**From:** [Gaudreau, Eric](#)  
**To:** [lighting@energystar.gov](mailto:lighting@energystar.gov)  
**Cc:** [Vyas, Shivani](#); [Lockner, Jeffrey](#)  
**Subject:** ENERGY STAR Recessed Downlights V1.0 First Draft Comments  
**Date:** Friday, April 21, 2023 4:33:01 PM  
**Attachments:** [image001.png](#)

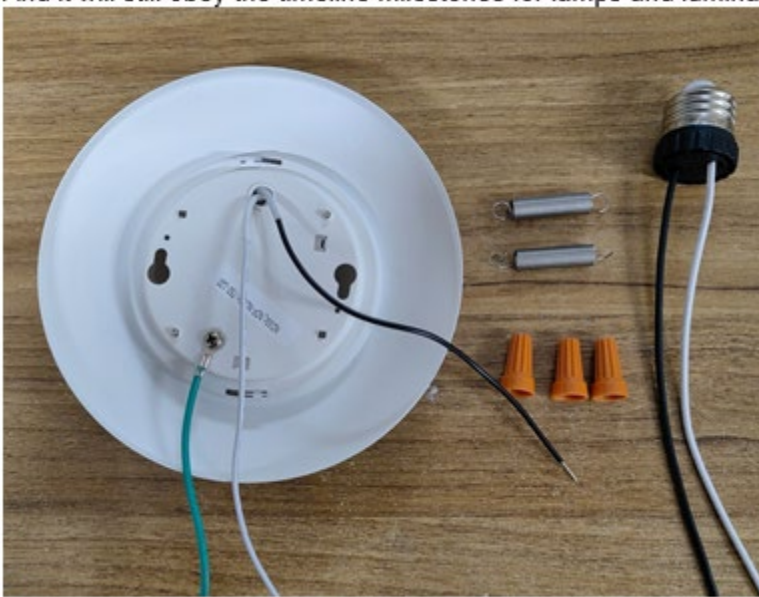
Scope/ Eligibility question: Are products that are sold and marketed as both a surface mounted downlight and a downlight retrofit kit eligible for certification? See example below for a retrofit product intended for surface mount or recessed downlight installations.
